METFORD MEDICAL

ARCHITECTURAL DRAWING SCHEDULE

ISSUE FOR DA

REVISION 2 UPDATES (01/12/23)

DRAWING : BUILDING B - ELEVATIONS & SECTIONS E-E, F-F

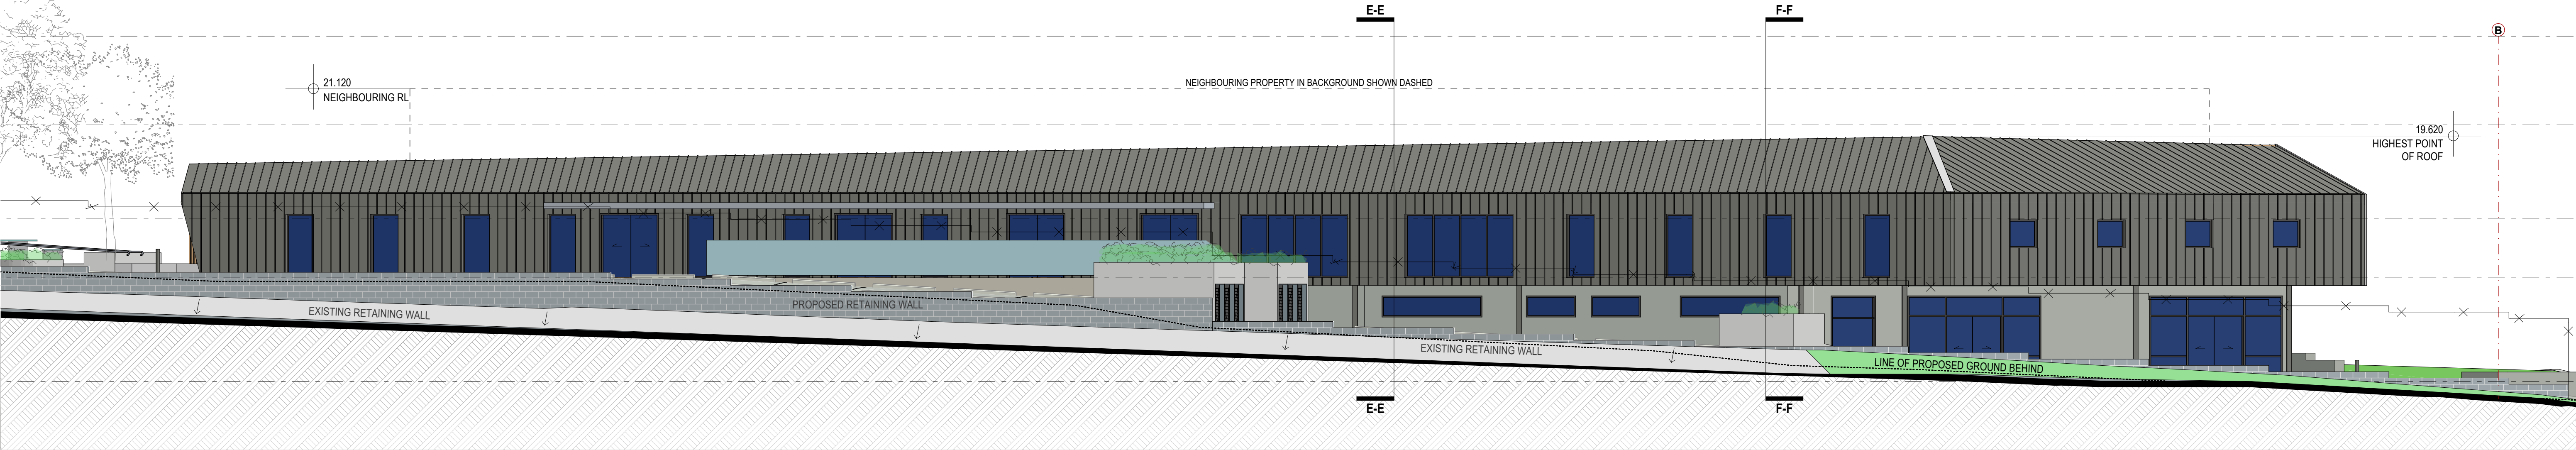
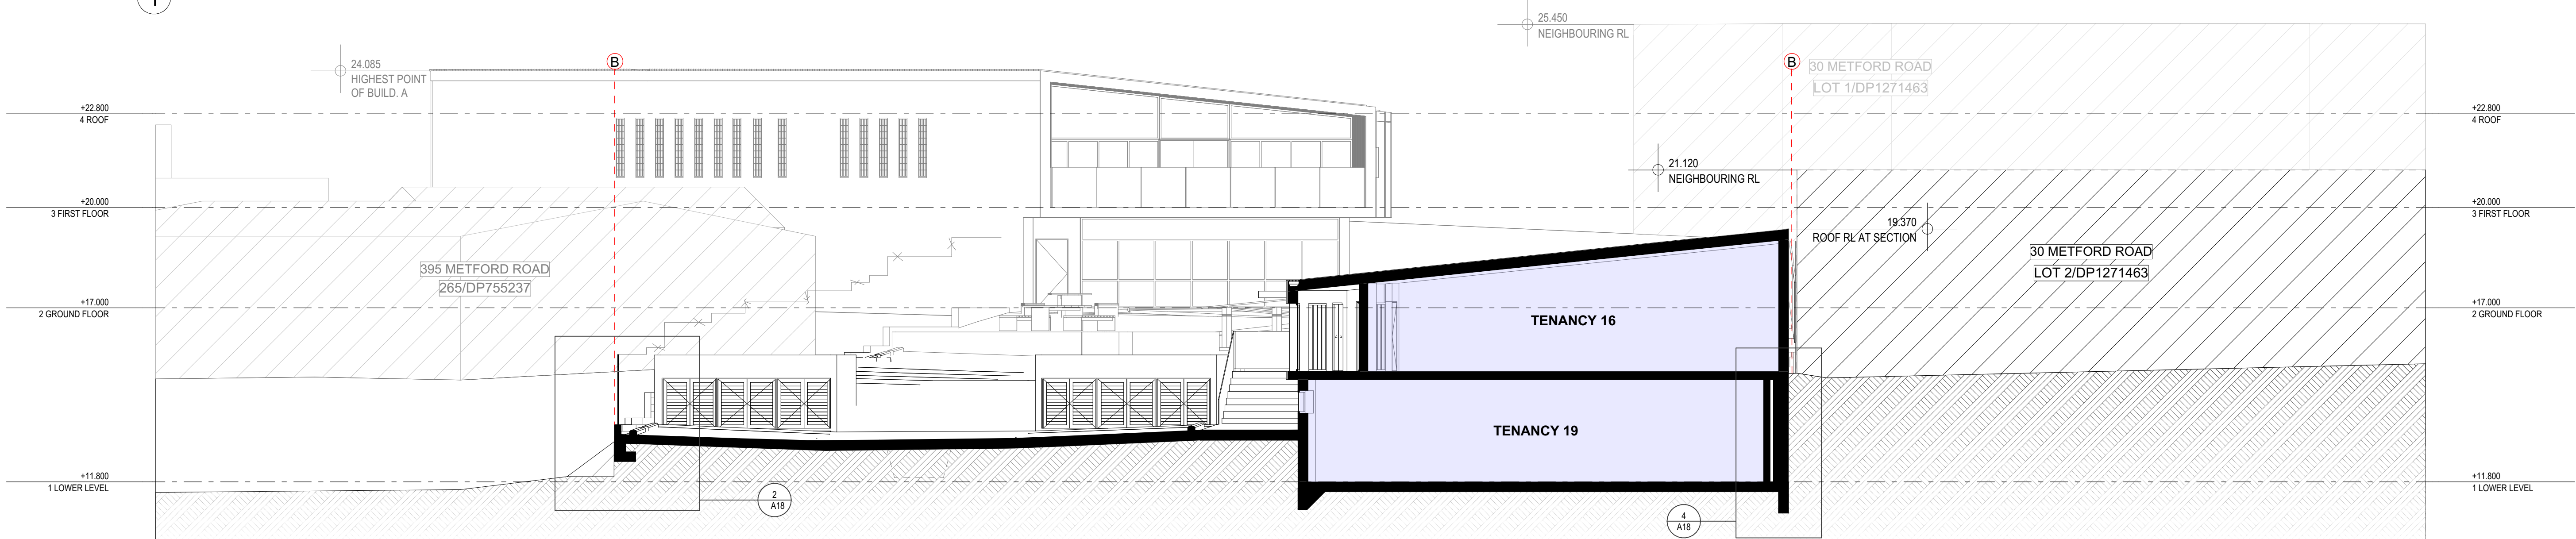
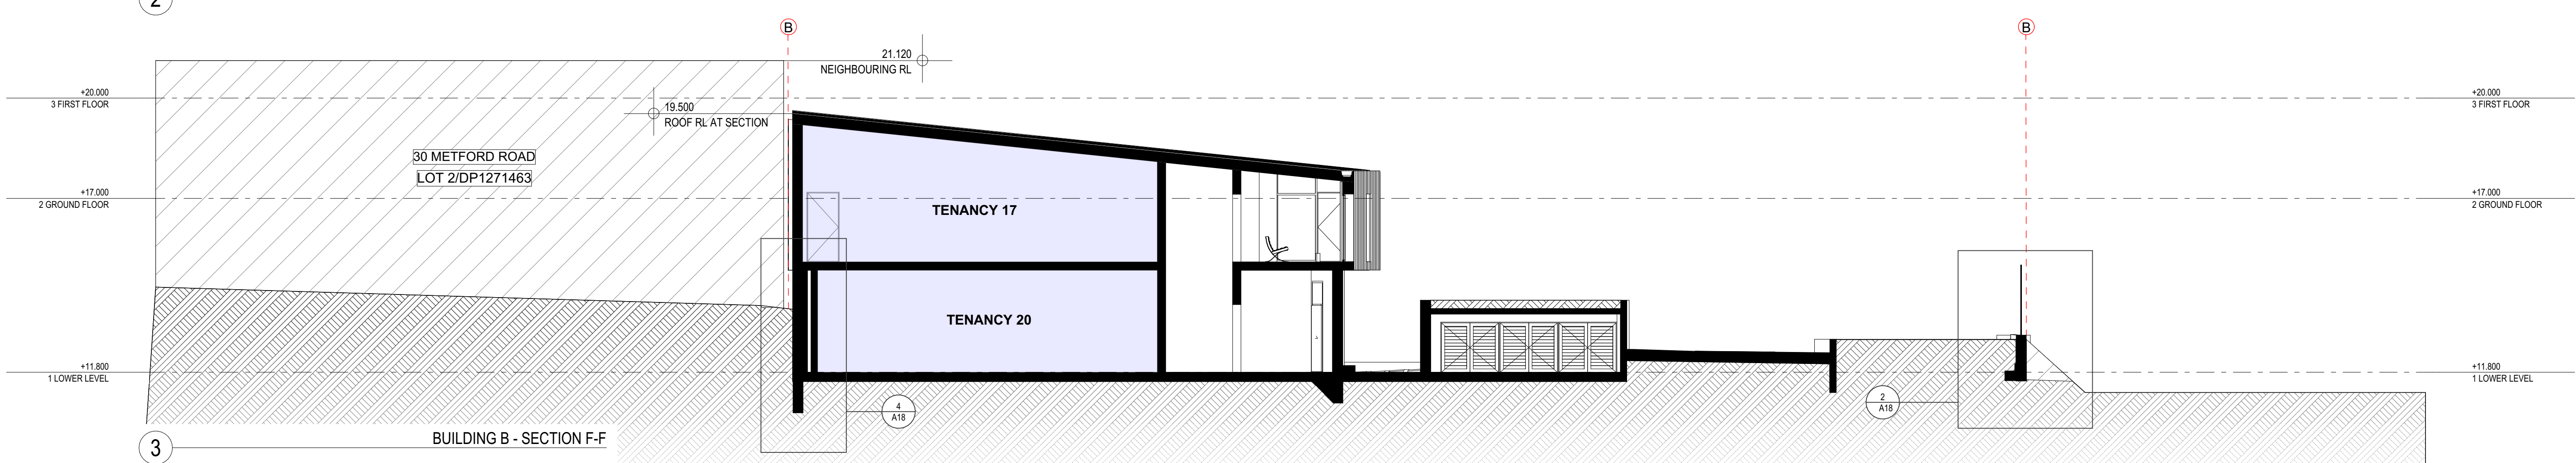
REVISION 2 UPDATES (01/12/23)
- BOUNDARY RETAINING WALL DETAILS SHOWN

DRAWING : RETAINING WALL DETAILS

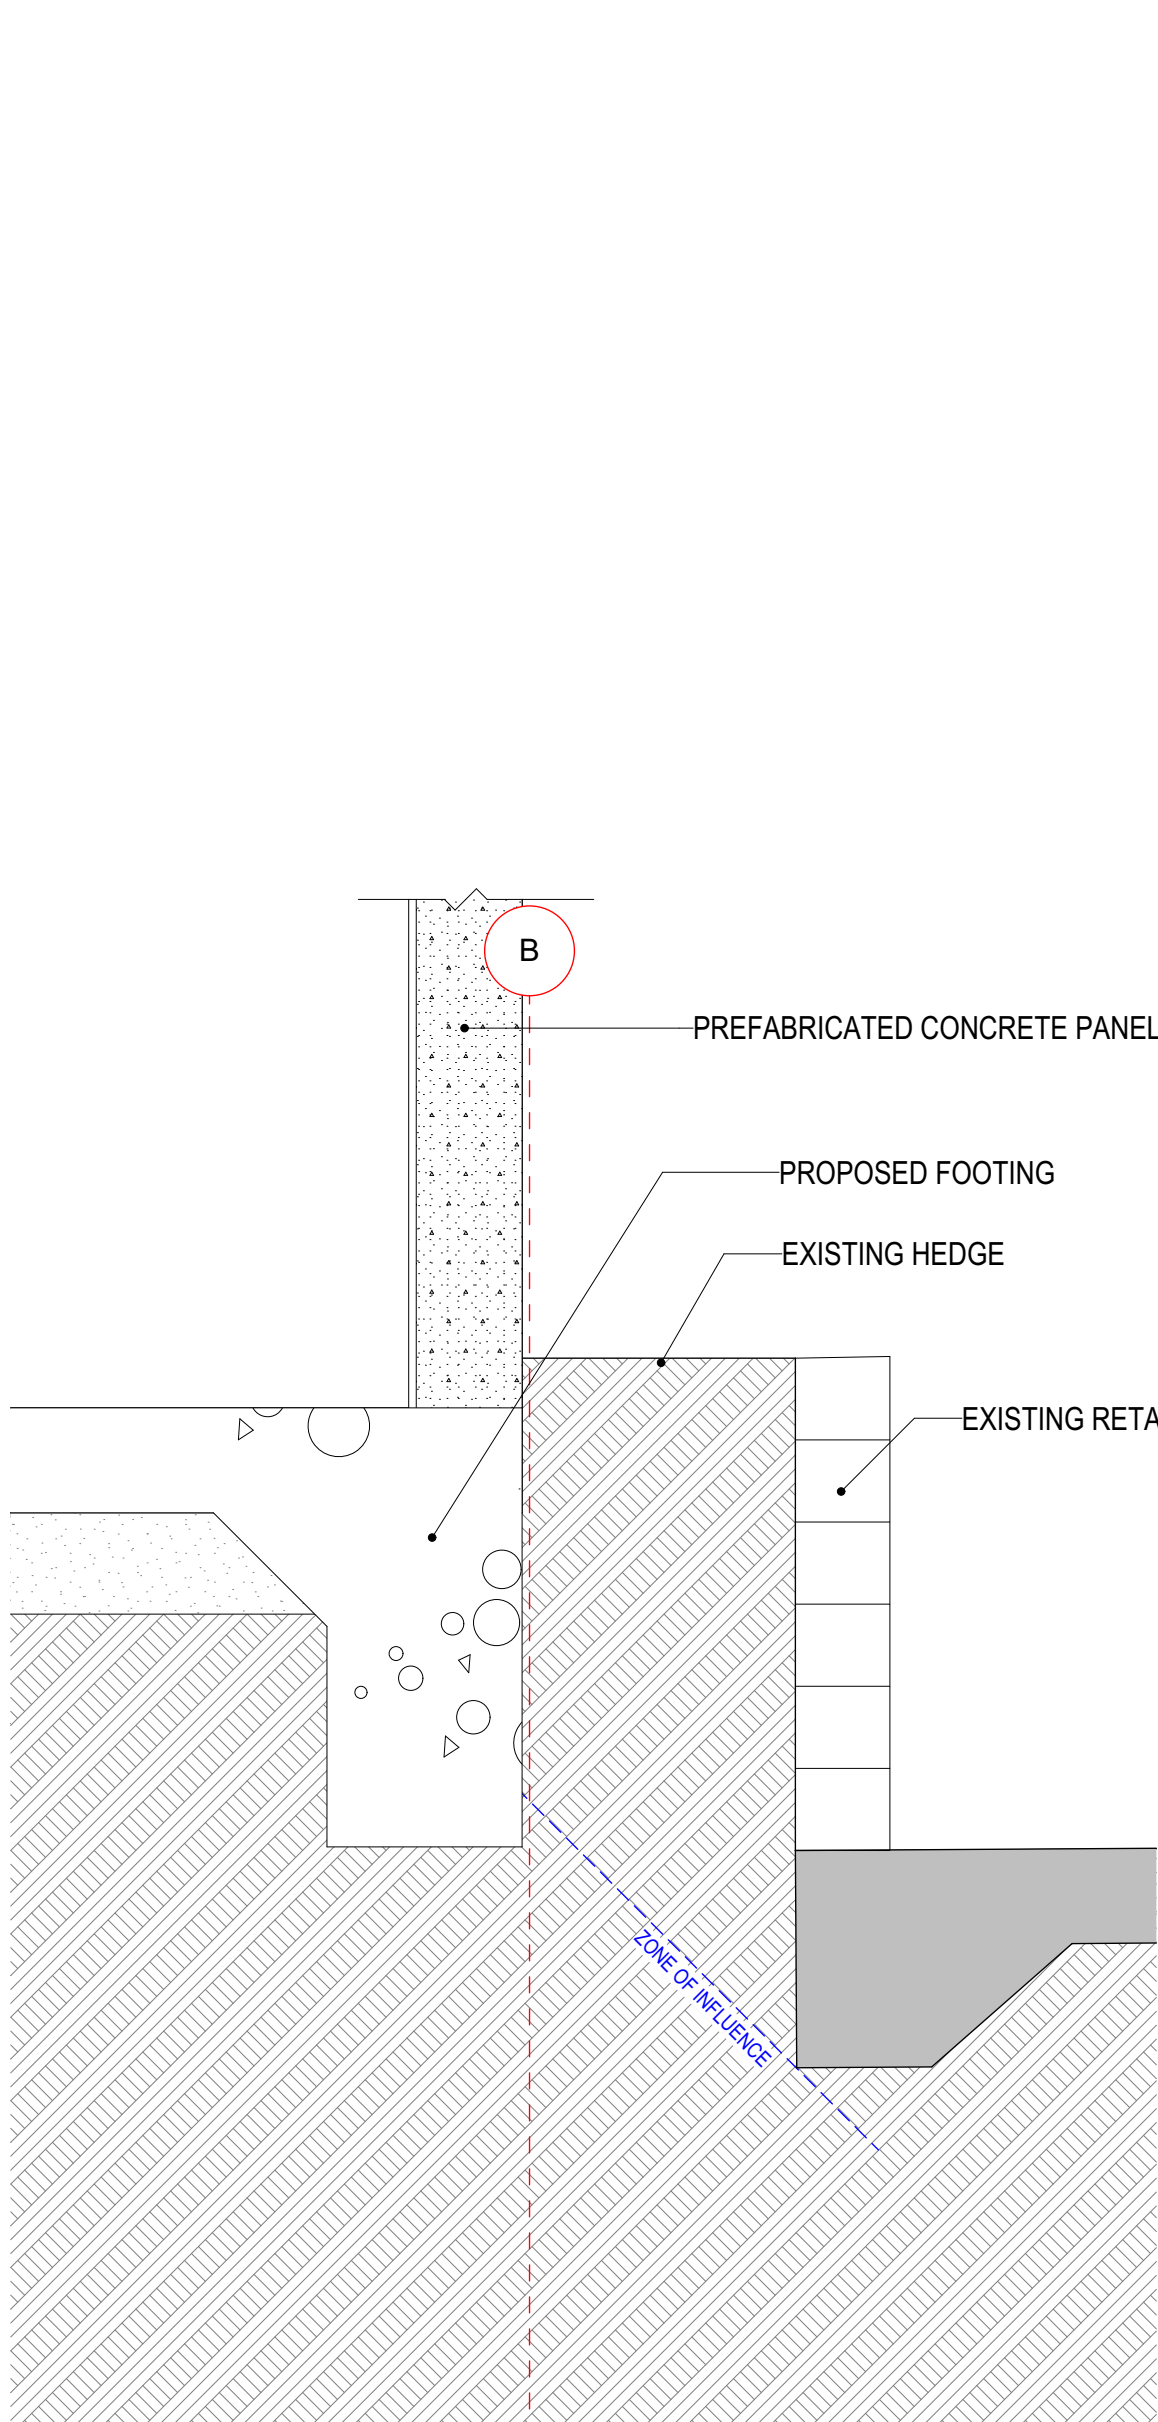
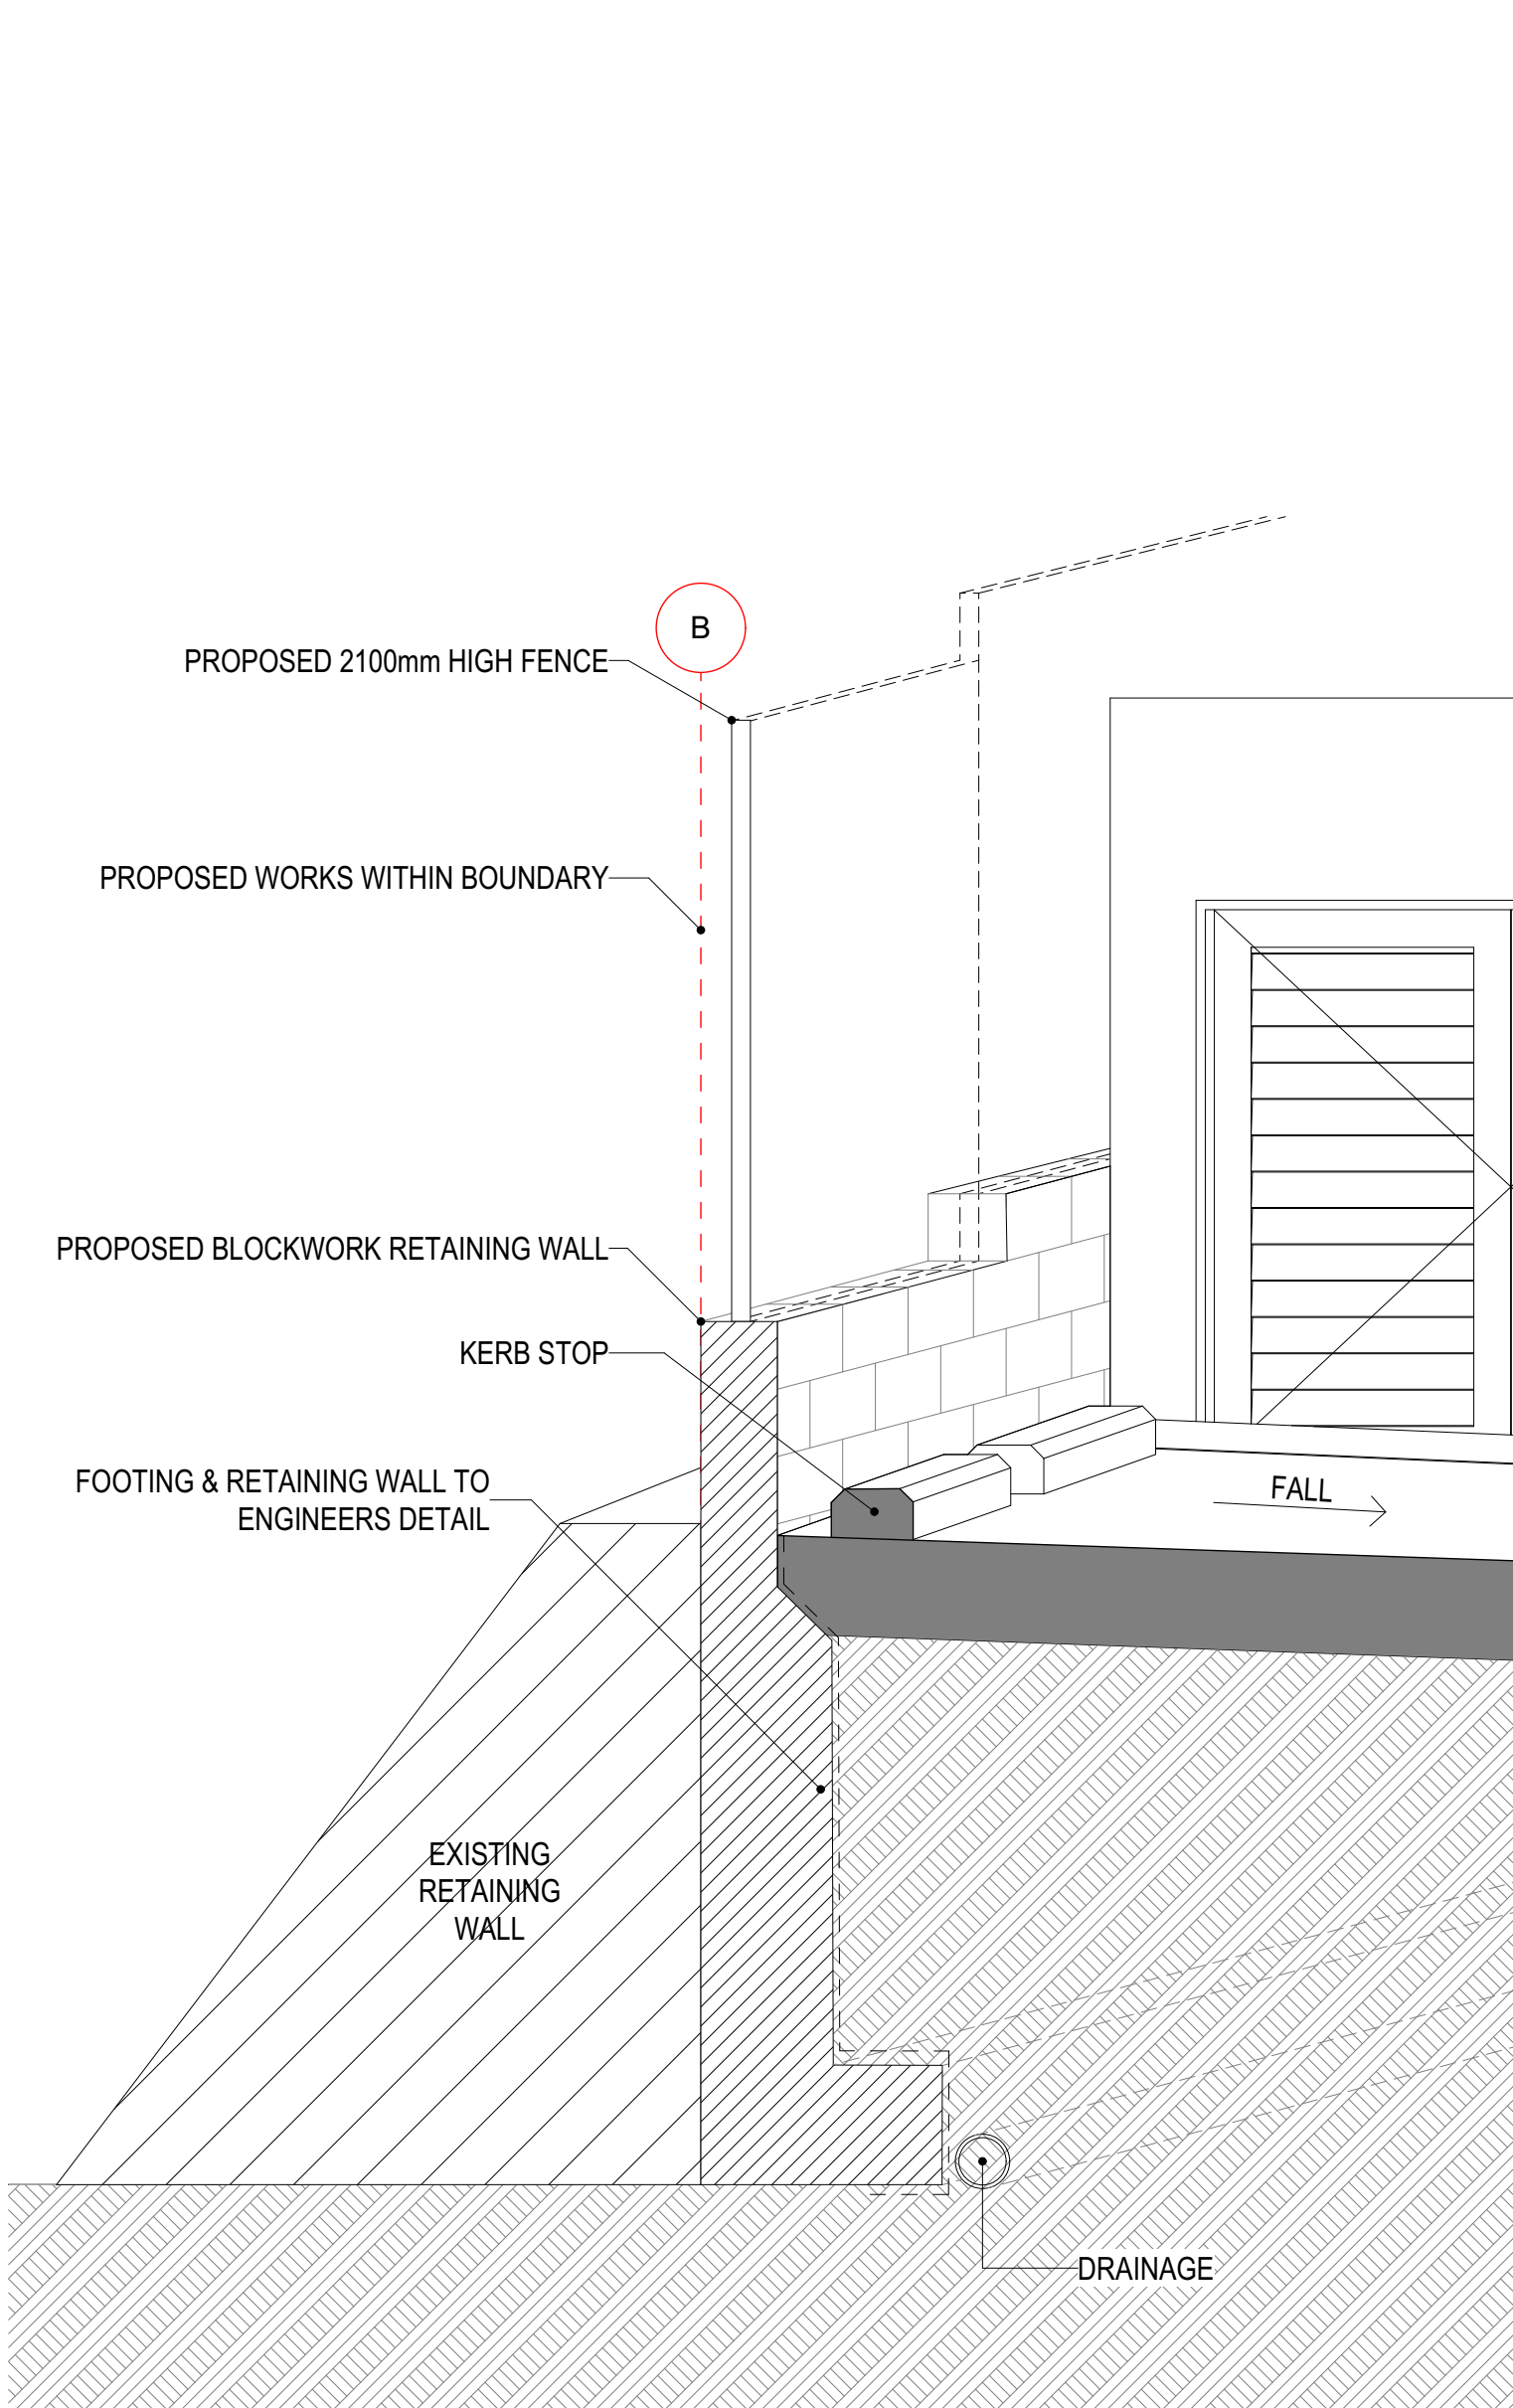
REVISION 2 UPDATES (01/12/23)
- RETAINING WALL DETAILS UPDATED & REFINED
